To: T10 Committee (SCSI)

Subject: SAS-2: SAM-4: Miscellaneous State Machine Fixes

Overview

Figure 1 — SL (link layer for SAS phys) state machines (part 1)

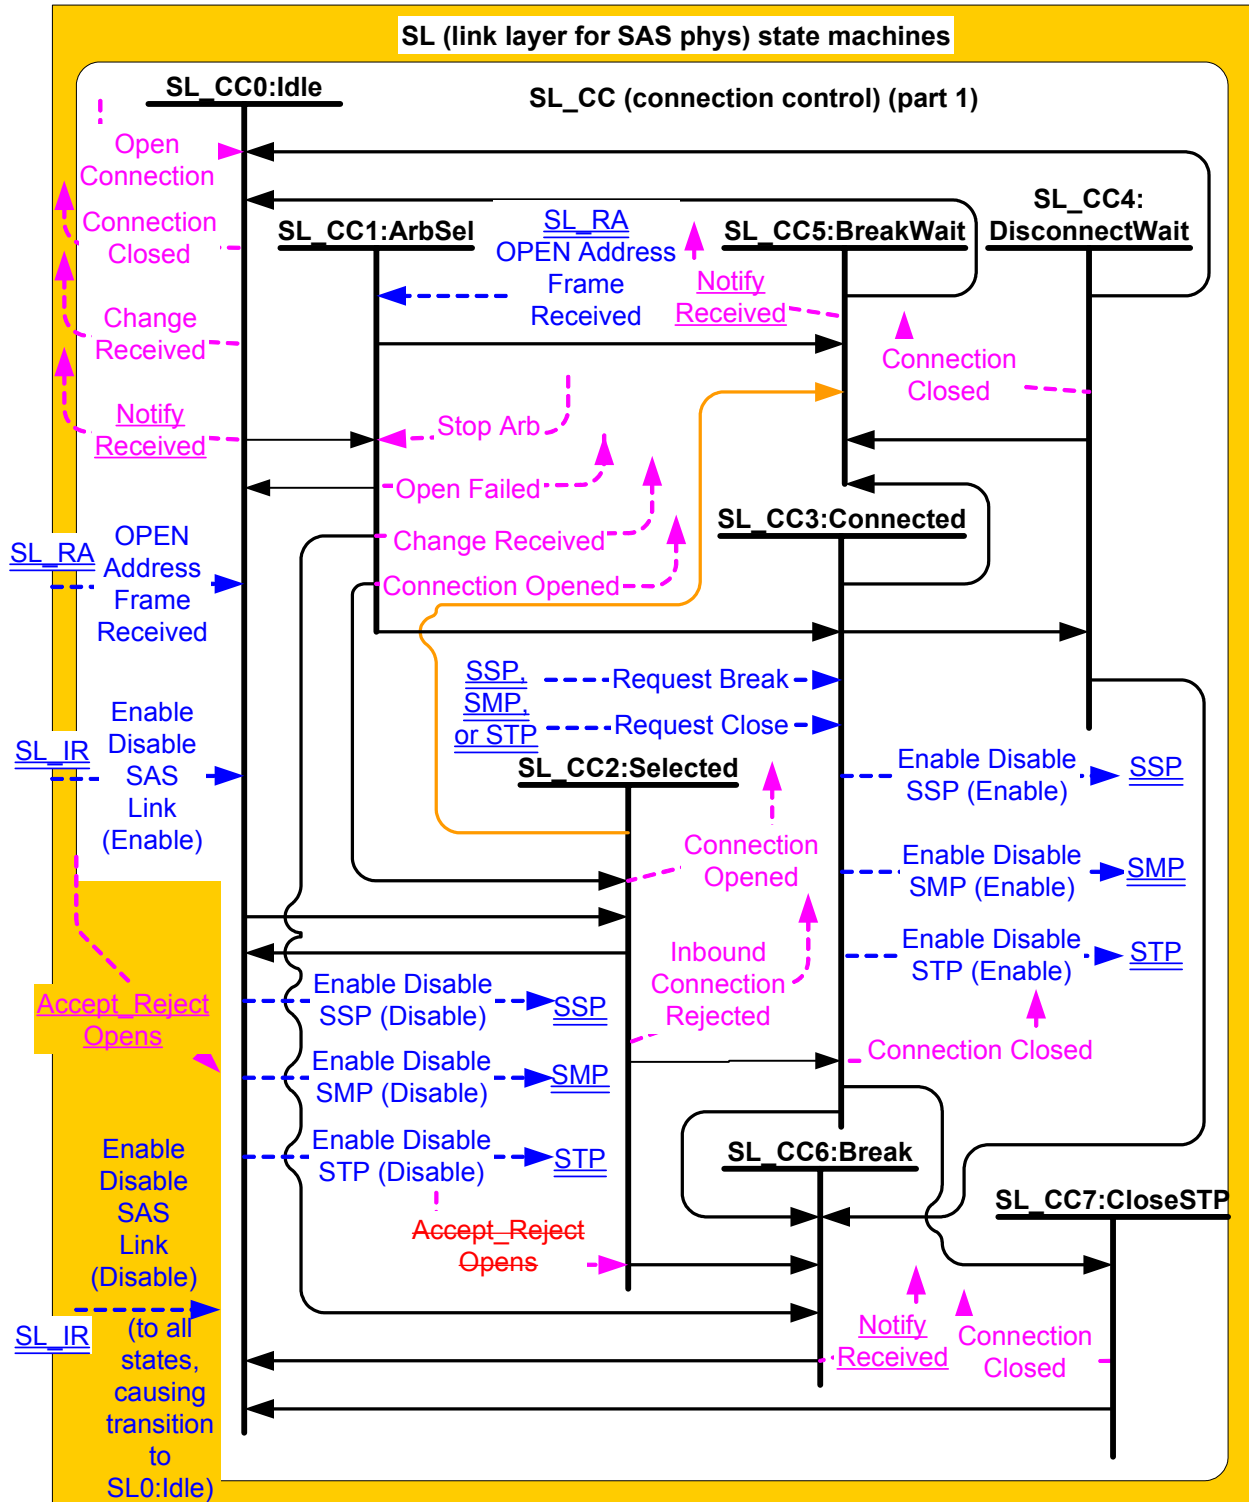
Editor's Note 3: Figure 1 has changed. The changes are indicated by the orange arrow and by underlines on the confirmations, requests, and messages.

Figure 2 — SL (link layer for SAS phys) state machines (part 2)

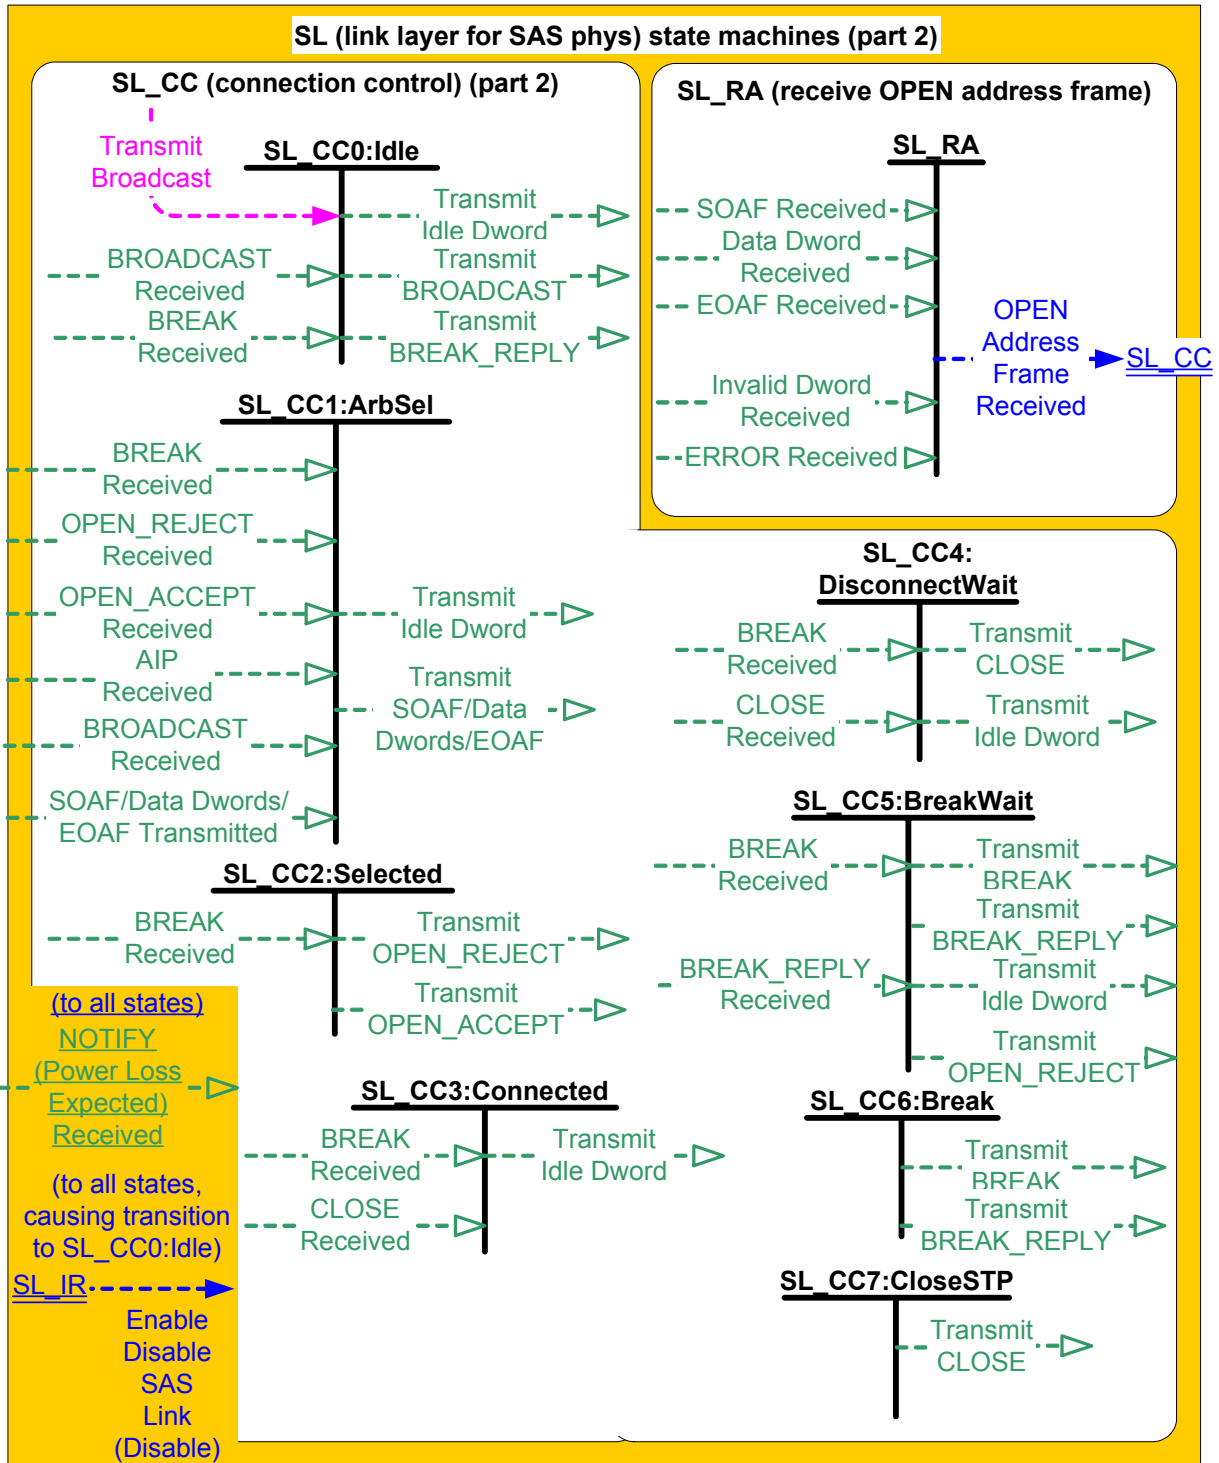
Editor's Note 4: Figure 2 has changed. The changes are indicated by underlines on the confirmations, requests, and messages.

Figure 4 — SSP (link layer for SSP phys) state machines (part 2 - frame reception)

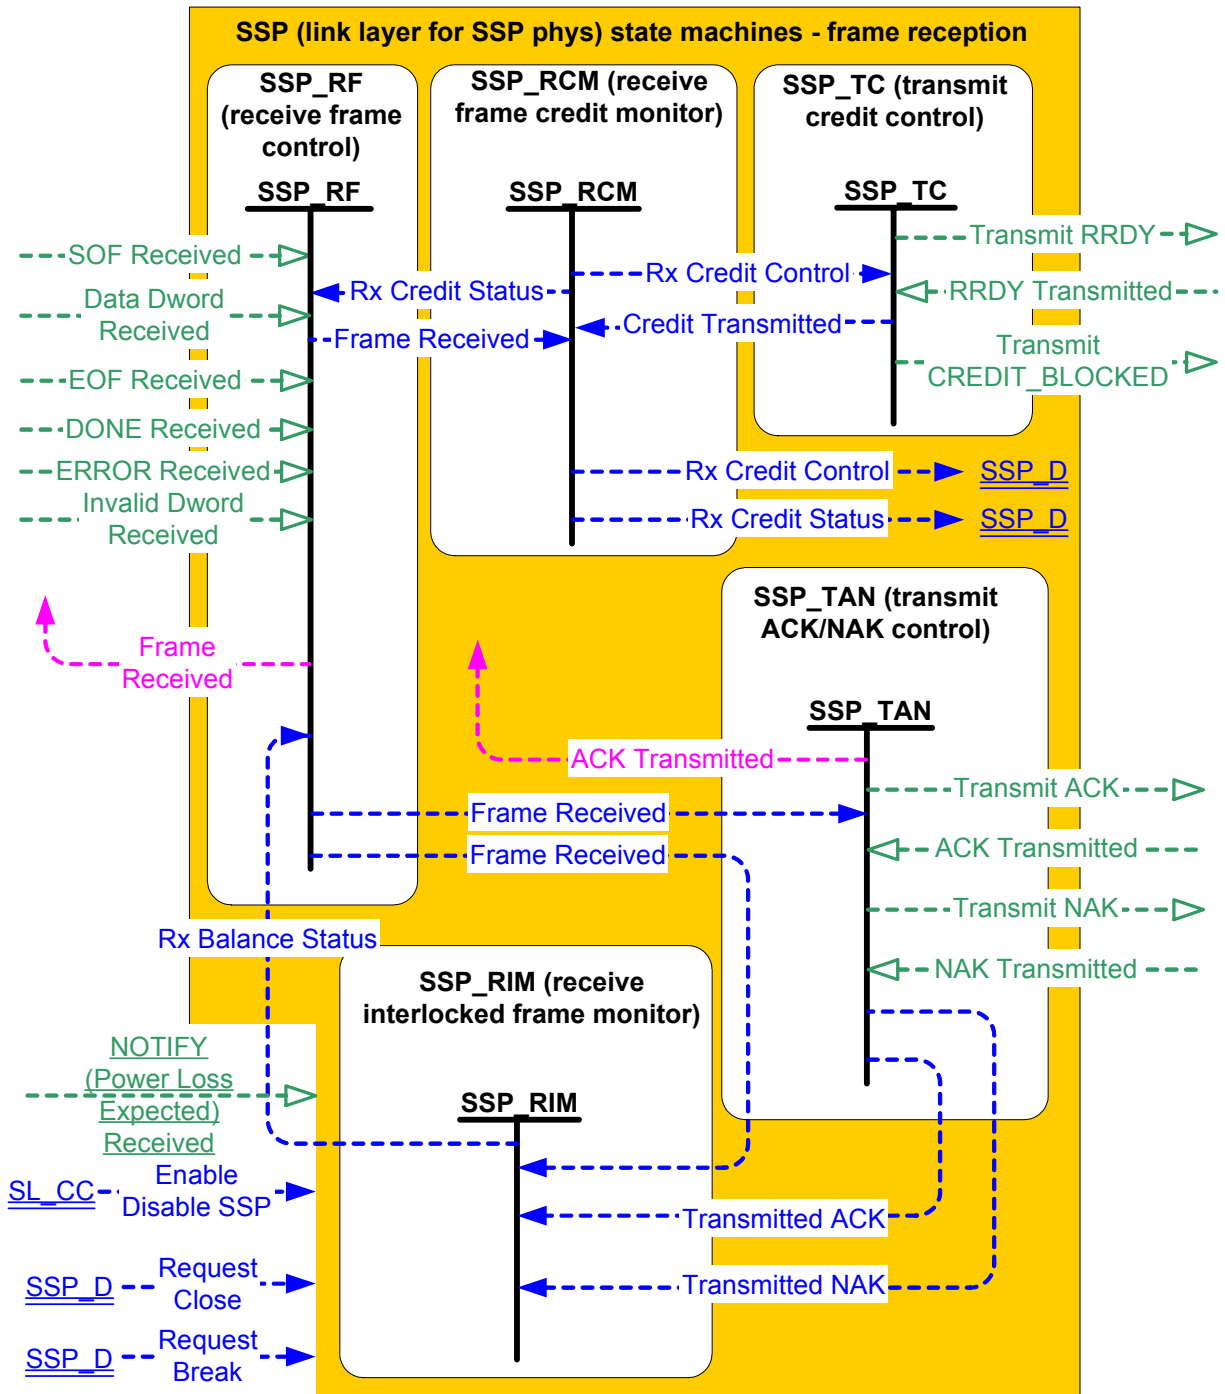
Editor's Note 5: Figure 4 has changed. The changes are indicated by underlines on the confirmations, requests, and messages.

Figure 5 — PL_OC (port layer overall control) state machine

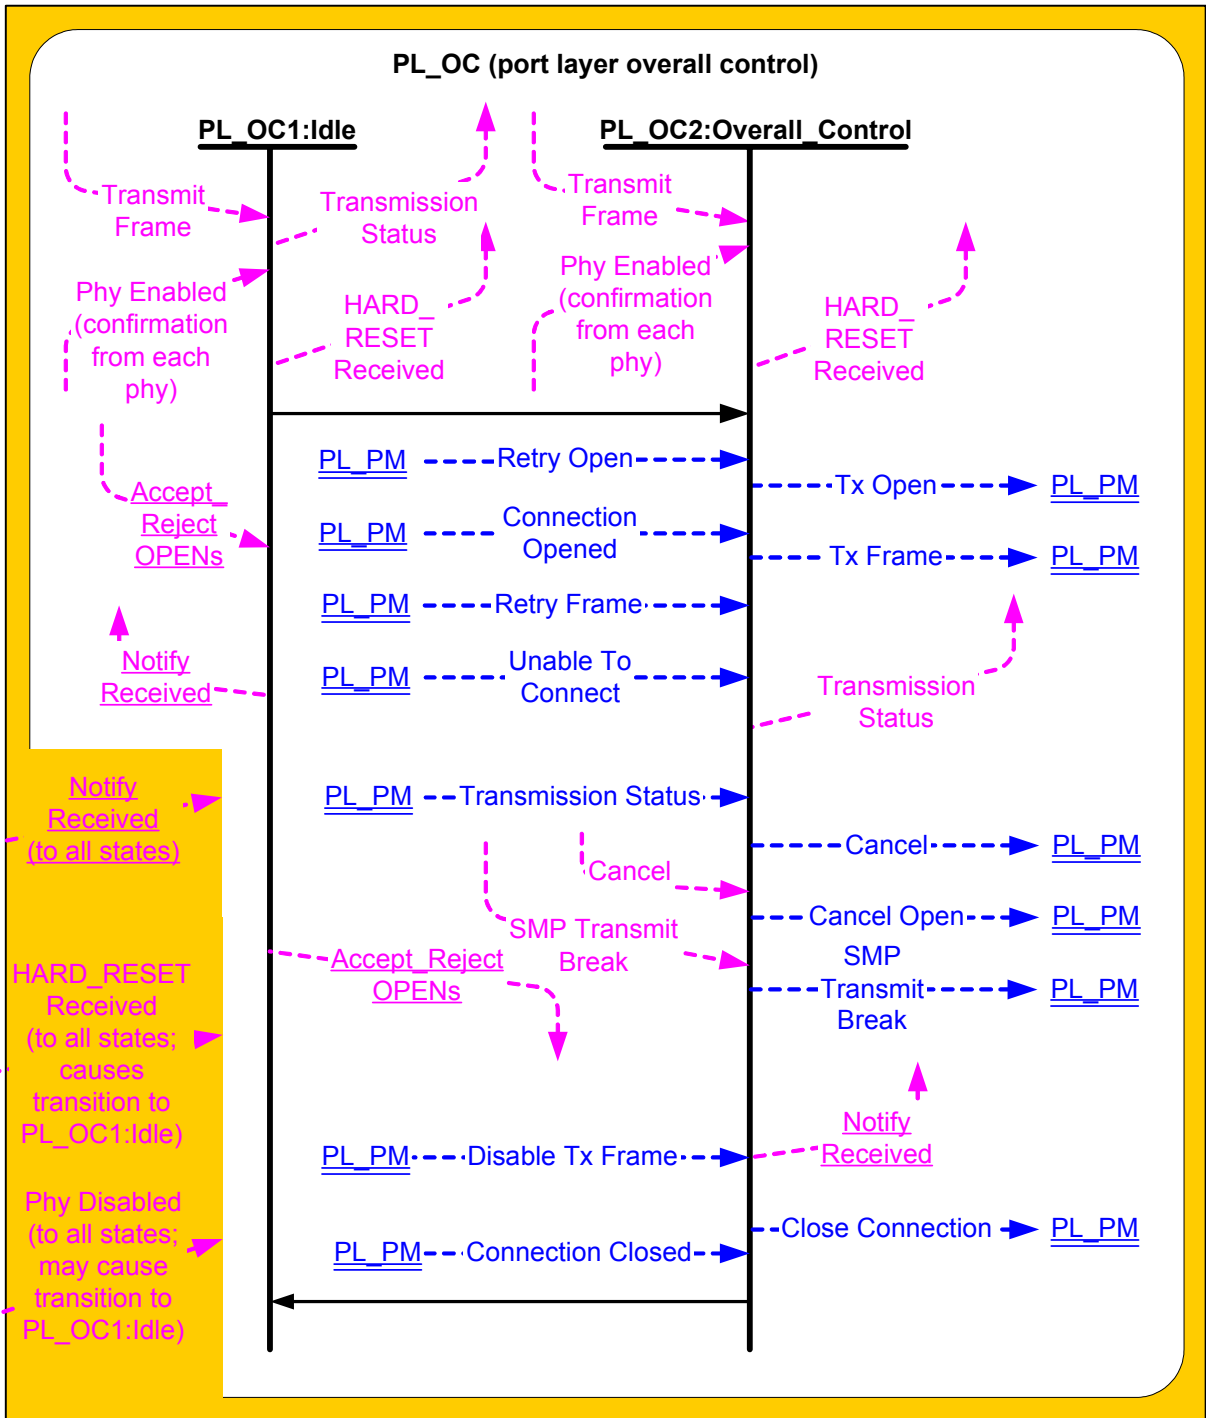
[Editor's Note 1: This message also needs to be added into the PL_PM state machine figure.](#)

Editor's Note 6: Figure 3 has changed. The changes are indicated by underlines on the confirmations, requests, and messages.

Figure 6 — ST_T (transport layer for SSP target ports) state machines

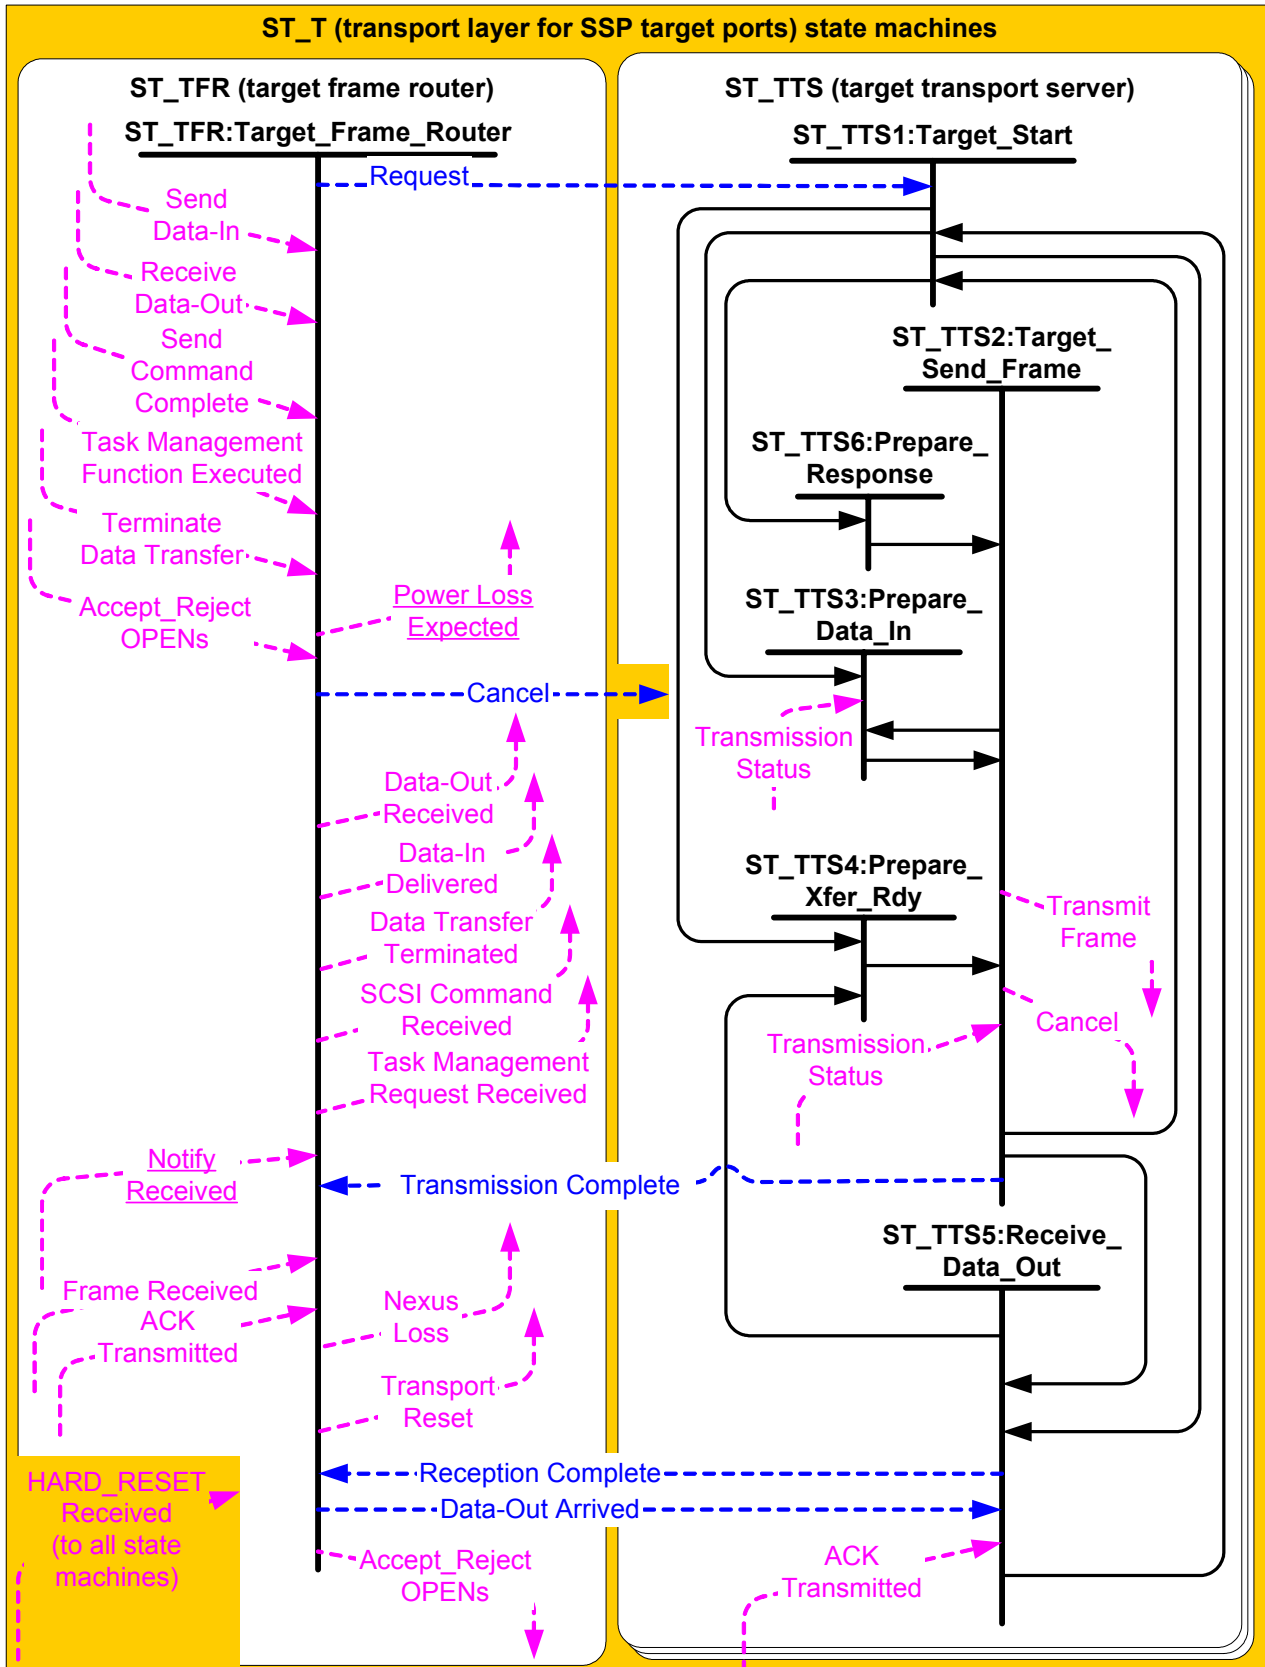
Editor's Note 2: There needs to be a Transmission Status confirmation arrow added to the ST_TTS5: Receive_Data_Out state in the ST_T state machine figure.

Editor's Note 7: Figure 4 has changed. The changes are indicated by underlines on the confirmations, requests, and messages.

Figure 7 — Events and event notifications for SCSI target devices

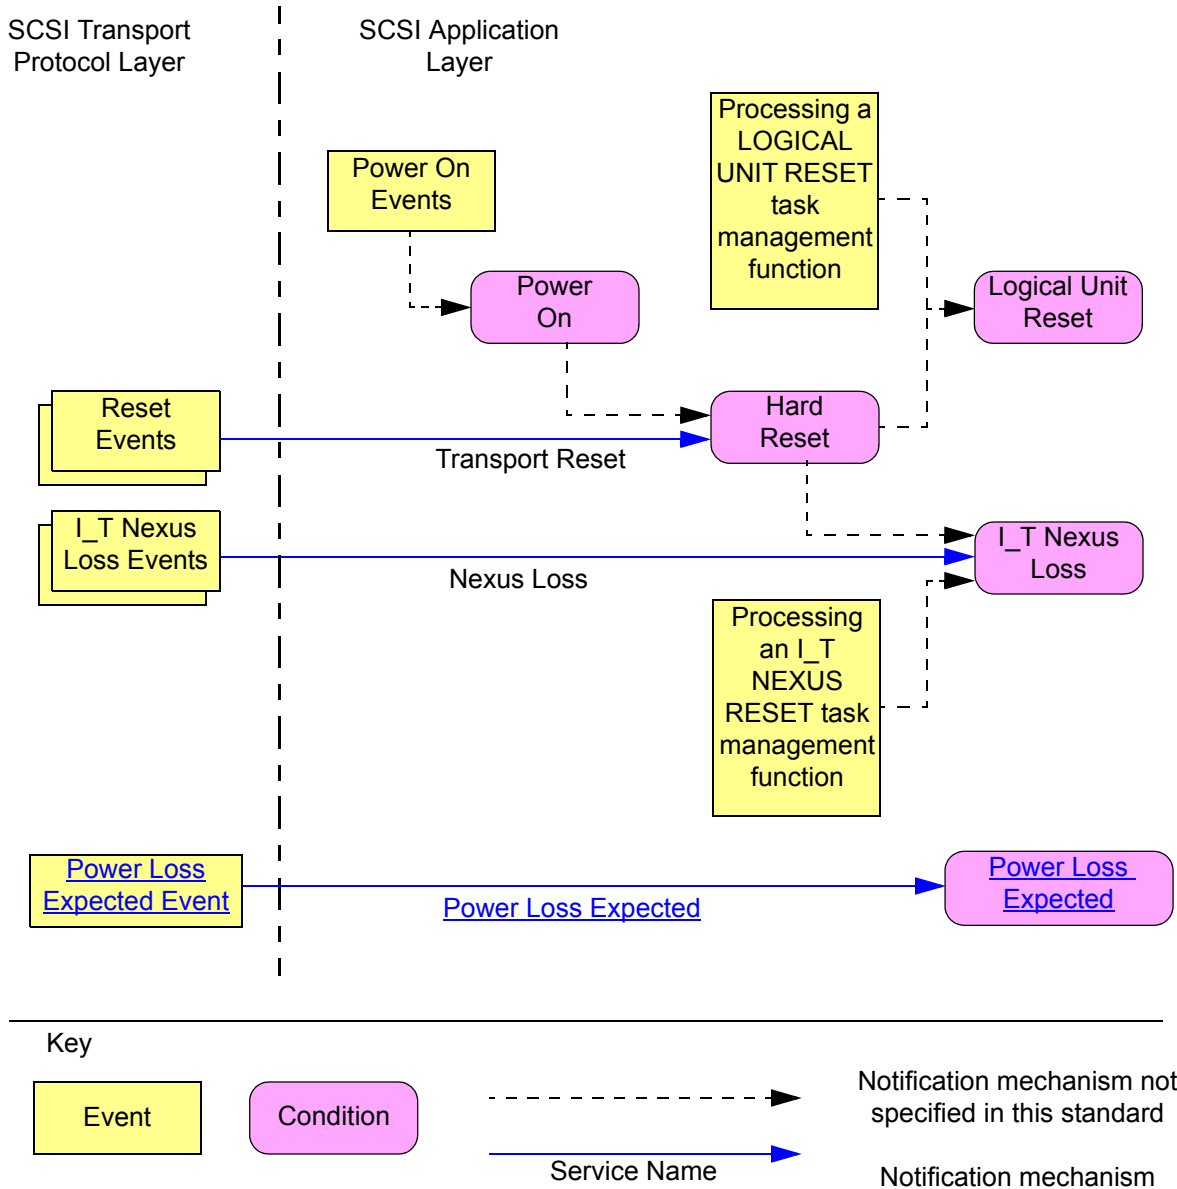
Editor's Note 8: Figure 5 has changed. The changes are indicated by blue underlines.
